**WATER OBSTRUCTION & ENCROACHMENT
ENGINEERING RECORD OF DECISION**

APPLICATION NO. E4129225-017

Permittee: [Pennsylvania General Energy Co., LLC](#) {[Kendra Schiappa – kendraschiappa@penngeneralenergy.com](#)}
 Application Type: New-Standard New-Small Project Chapter 106 Major Amendment
 Project Name: [Saluda Access Road and Staging Area](#)
 County: [Lycoming](#)
 Municipality: [Gamble & Cascade Townships](#)
 Does the application require a P.E. Seal? Yes [Peter Staudenmeier {\[pstaudenmeier@cecinc.com\]\(mailto:pstaudenmeier@cecinc.com\)}](#)

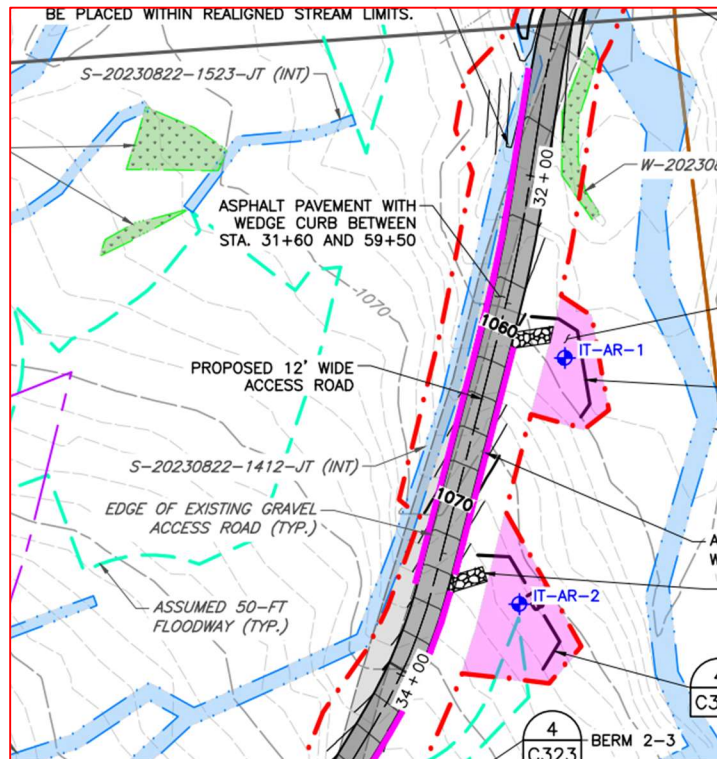
1. Plan drawings and cross sections (plans) have been updated based on responses to technical deficiency notices sent by the Department on 11/20/2025 & 2/9/2026 but still include at least the following deficiencies:
 - Plans at station 32+50 depict the proposed access road cut within existing grades lower than the grades proposed on either side of the roadway. The proposed grading fails to:
 - i. Maximize protection of existing drainage by maintaining flow of the proposed stream relocation within the proposed stream channel as required by §105.13(e)(1)(x)

- ii. Manage stormwater runoff from the access roadway through the designed SCM (infiltration berm 2-1) as required by §105.13(e)(1)(v)

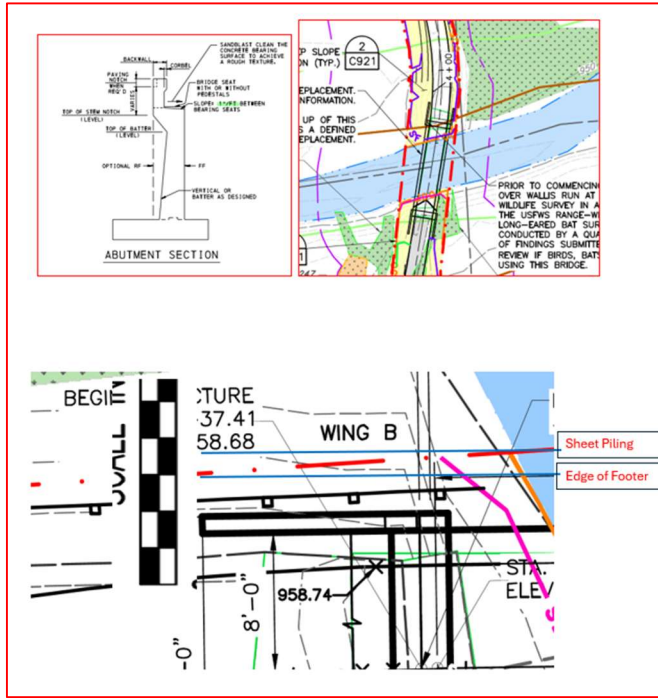
- Plans provided are inconsistent with each other not meeting the requirements of §105.13(e)(1)(i). Sheets C314 & C914 depict Culvert 23A with a drop inlet structure located approximately at ST140+50 and a bridge located approximately at ST139+50 but sheets C401 and C503 depict Culvert 23 at ST139+58.
- Plans have been updated to show sheet piling installed for the bridge construction at Wallis Run located near ST4+00 to detail excavation limits. Sheet piling is proposed immediately adjacent to Wing B but plans appear to indicate a spread footing design for wingwalls. Please clarify if excavation limits are feasible as proposed at this location. §105.13(e)(1)(i).

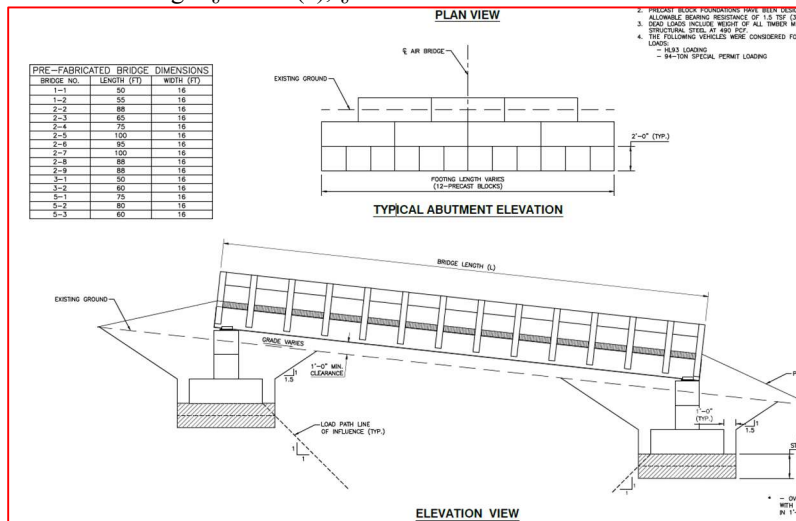
- Plans have been revised to show additional bridge crossings at multiple locations but provide only typical abutment construction details with the note “*Abutment and wingwalls for bridge structure will be designed by the bridge manufacture in accordance with appropriate loading and will accommodate the grading as shown on these plans*” despite the bridges ranging from 50 to 100 feet in length. Clarify if any geotechnical studies have been performed at these locations and evaluate whether excavation limits for bridge construction can remain within the LOD, if sheet piling is needed at any of these areas, or if bridge specific abutment designs are needed requiring larger areas of disturbance at each bridge. §105.13(e), §105.151

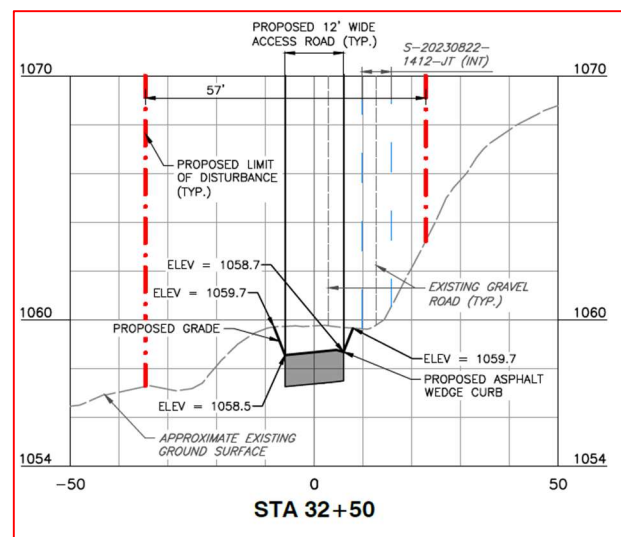
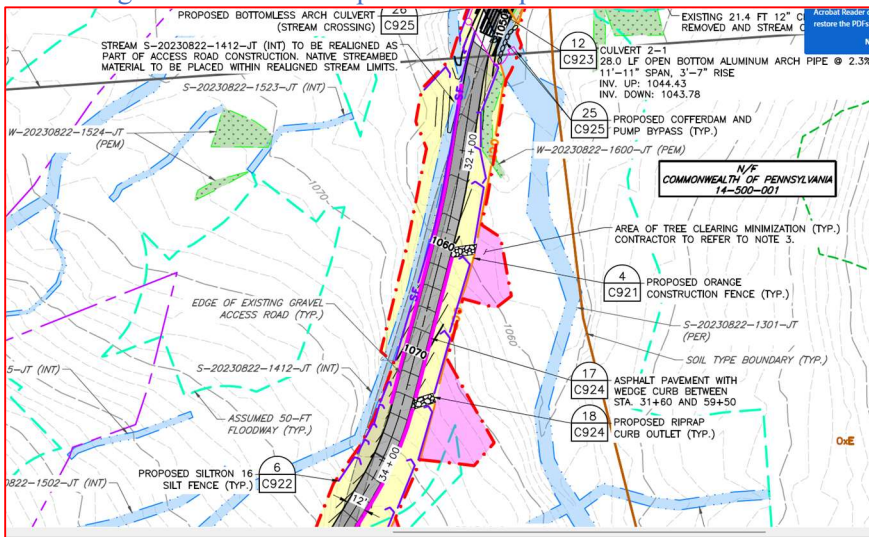
PGE does not propose mitigation for stream S-20230822-1412-JT (UNT to Wallis Run; 41.406855, -76.869182), which would be realigned during construction. Stream relocations are permanent impacts and require mitigation under §105.1.

Additionally, this stream would be located immediately adjacent to the proposed road and at sections, would be at a higher elevation than the road surface and proposed curbing. The Department is not favorable of this design as proposed because the proximity of the road would affect stream flow dynamics and in-stream habitat resulting in significant adverse impacts to the aquatic resource.

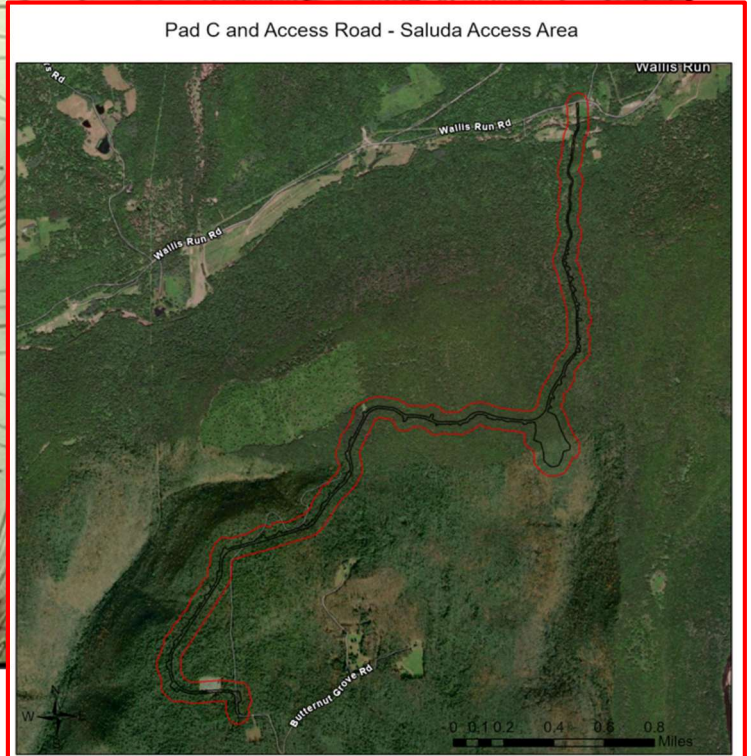
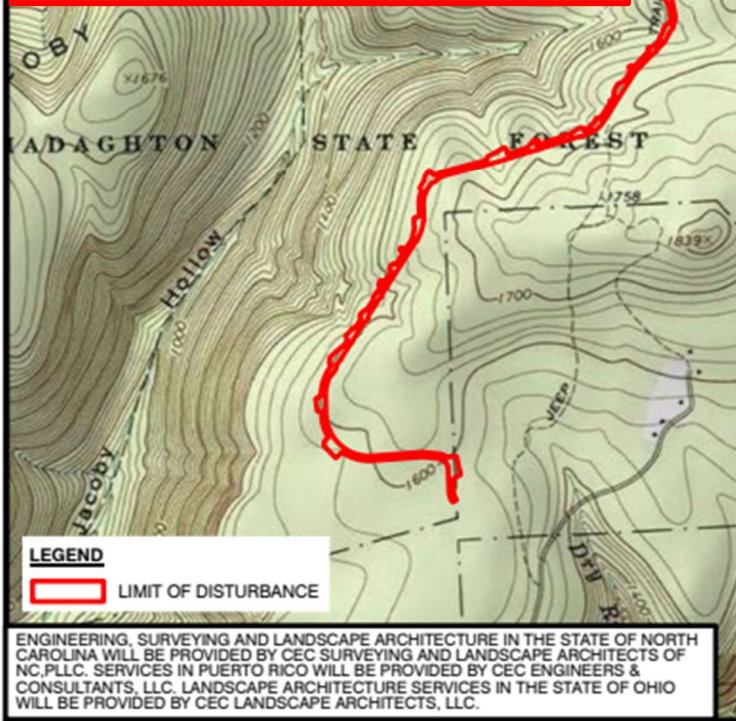
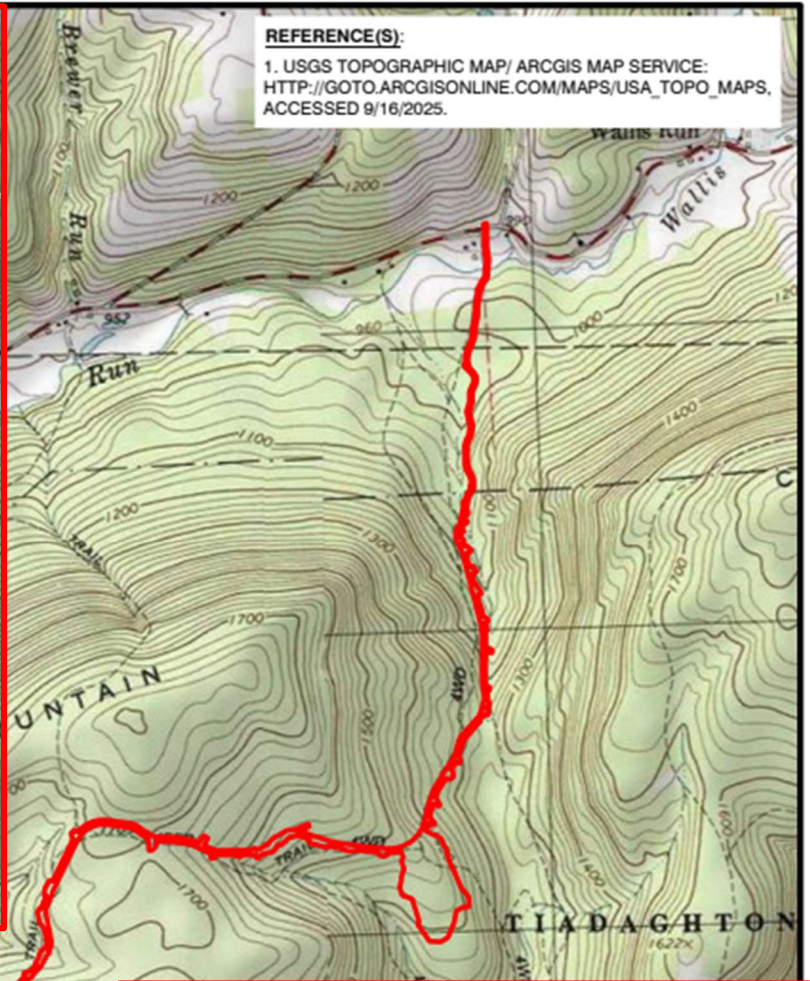
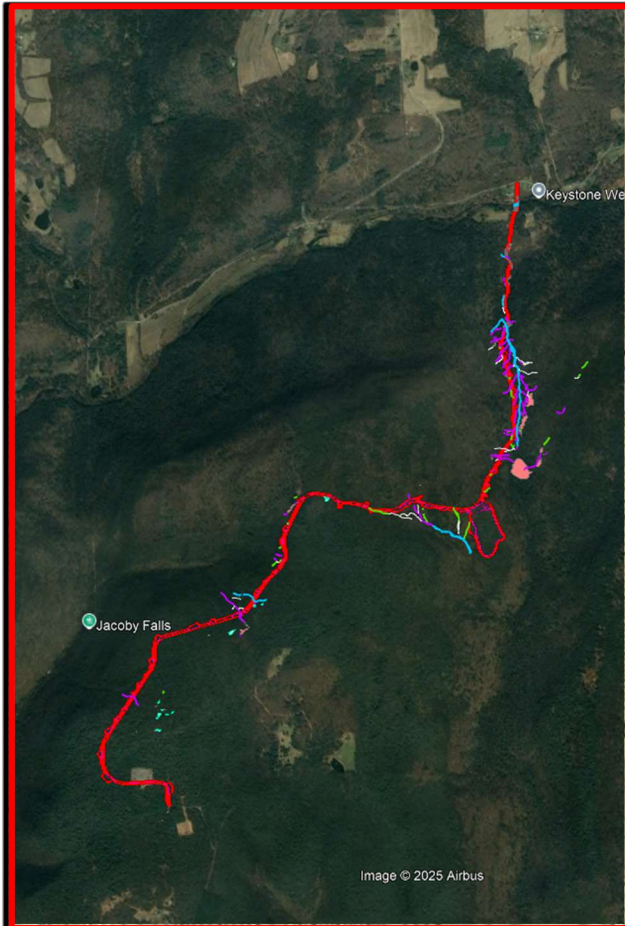
TD sent on 11/20/2025 - Provide additional evaluation on minimization of disturbance within stream areas. Drop inlets, manholes and riprap aprons within streams have been designed as E&S BMPs to remove energy and spread out water from culverts. Please reevaluate the need for and consider greatly reducing or removing the E&S BMPs minimize impacts to the stream resources. The project plans indicate that a portion Stream 20230822-1412-JT will be 'reconstructed' between Stations 31+00 and 34+00. The project plans do not include cross sections or plan details of the stream relocation. Please provide cross sections and plan details of the proposed stream relocation, and an explanation of why the road could not be designed to avoid relocating the stream.

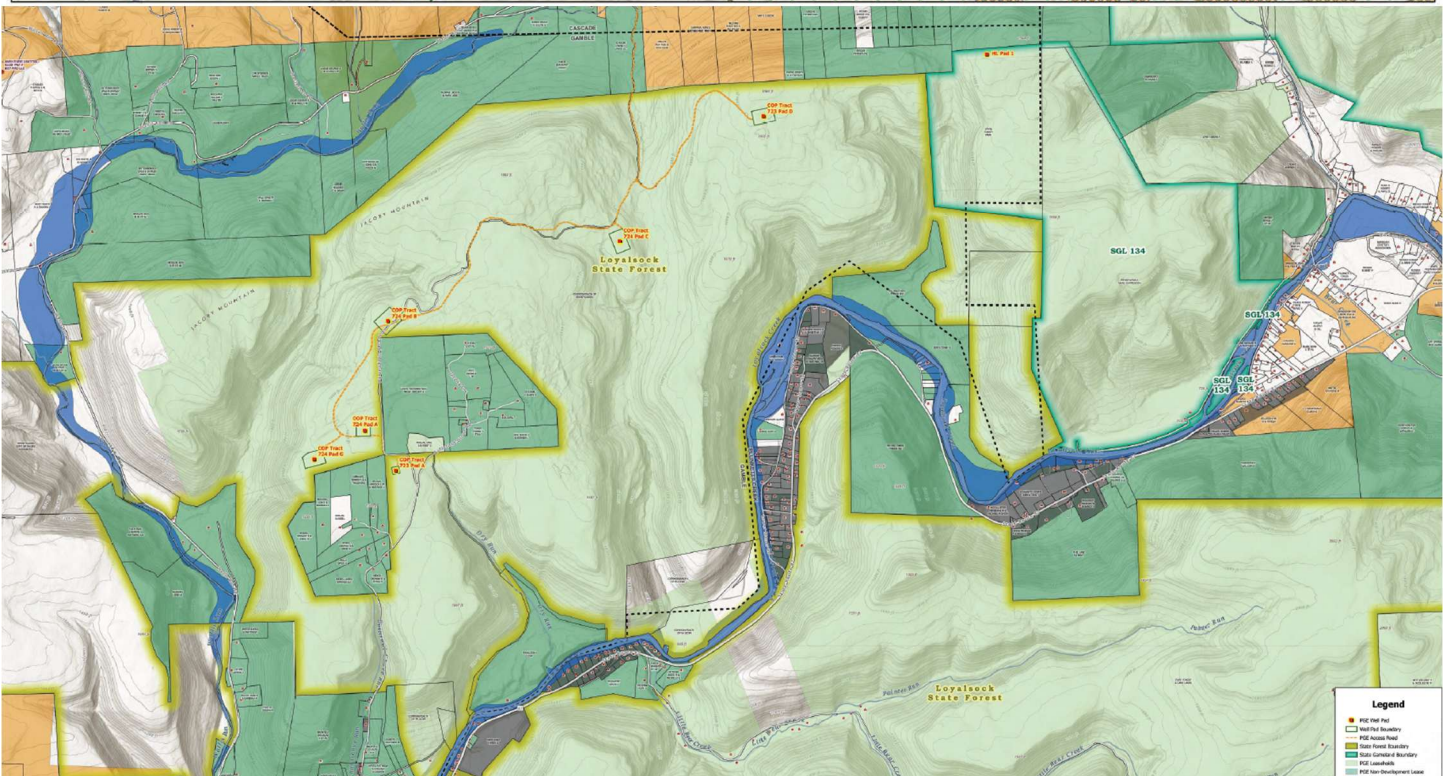
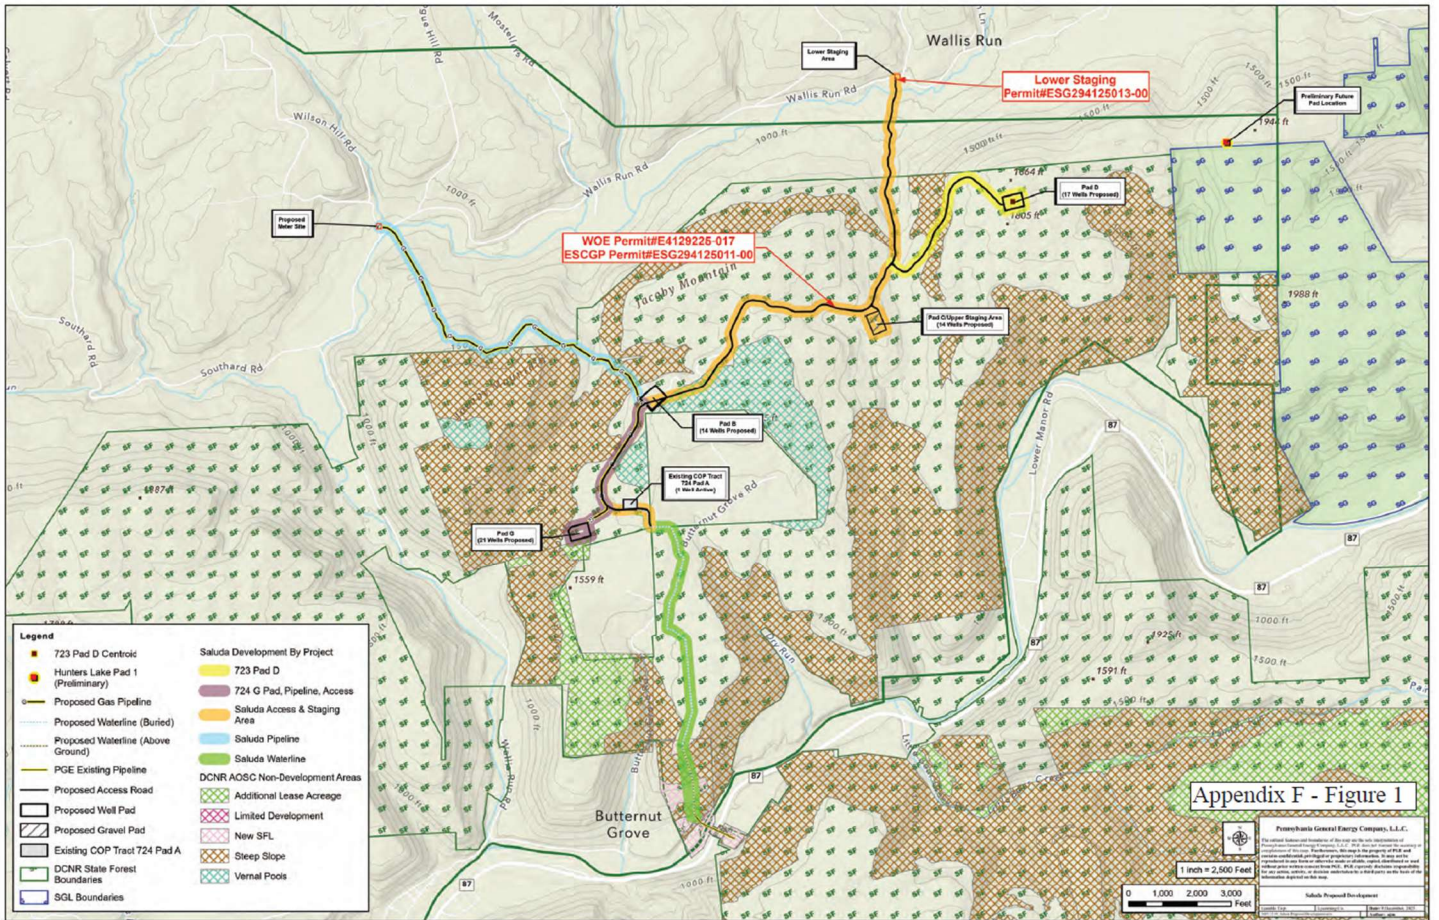
Due to the proposed alignment of the access road, stream channel S-20230822-1412-JT and its floodway are to be impacted for an unknown length. This will require relocation of the existing channel. Please provide a longitudinal profile and cross sections of the existing channel as well as construction details depicting the location, profile, and cross section of the reconstructed channel.

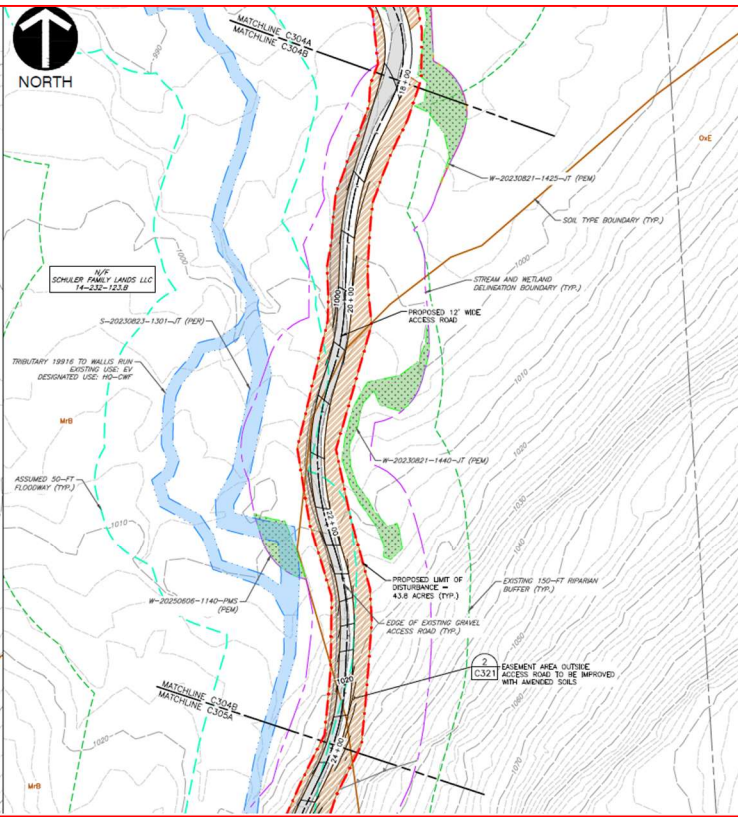
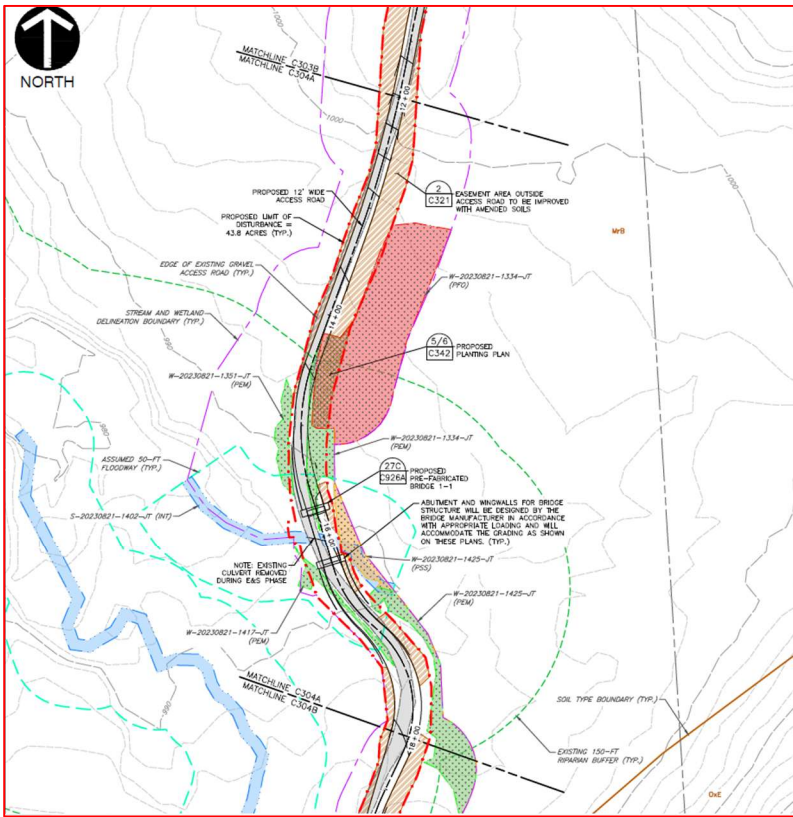
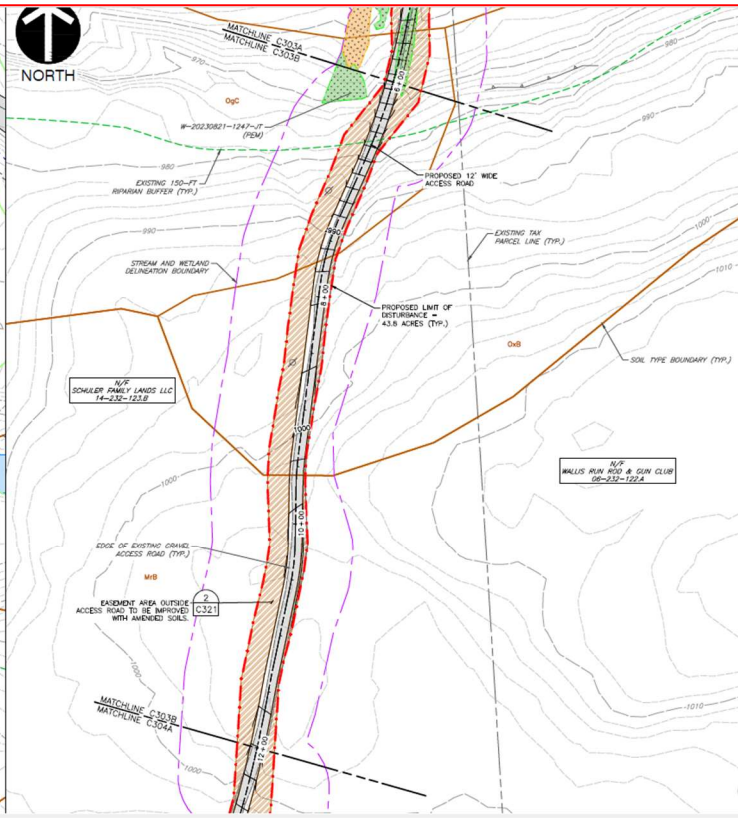
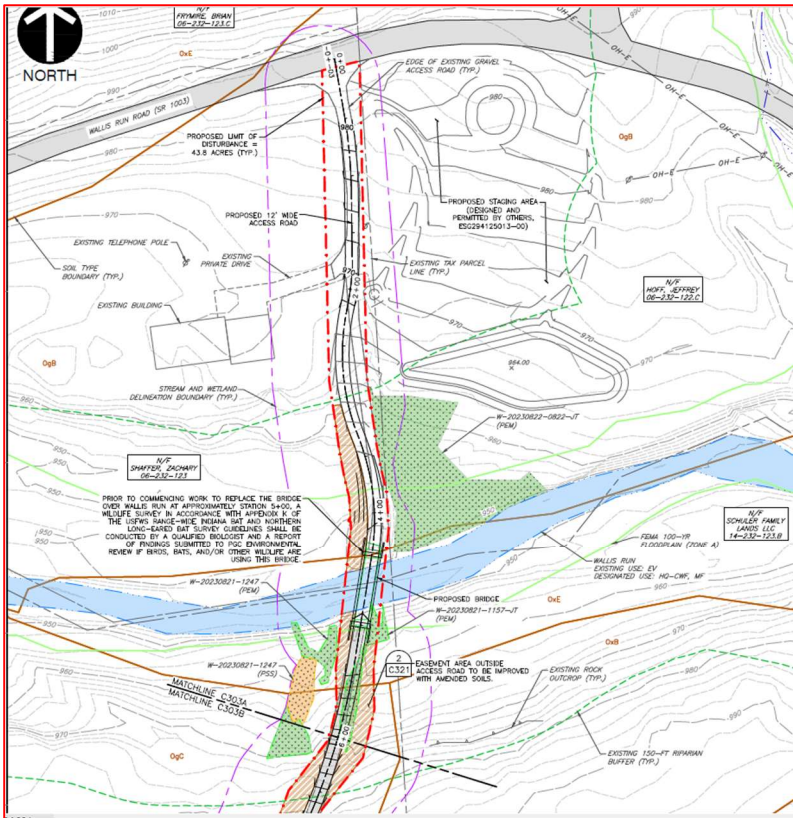
TD sent on 11/20/2025 - The project plans indicate that a portion Stream 20230822-1412-JT will be 'reconstructed' between Stations 31+00 and 34+00. The project plans do not include cross sections or plan details of the stream relocation. Please provide cross sections and plan details of the proposed stream relocation, and an explanation of why the road could not be designed to avoid relocating the stream.
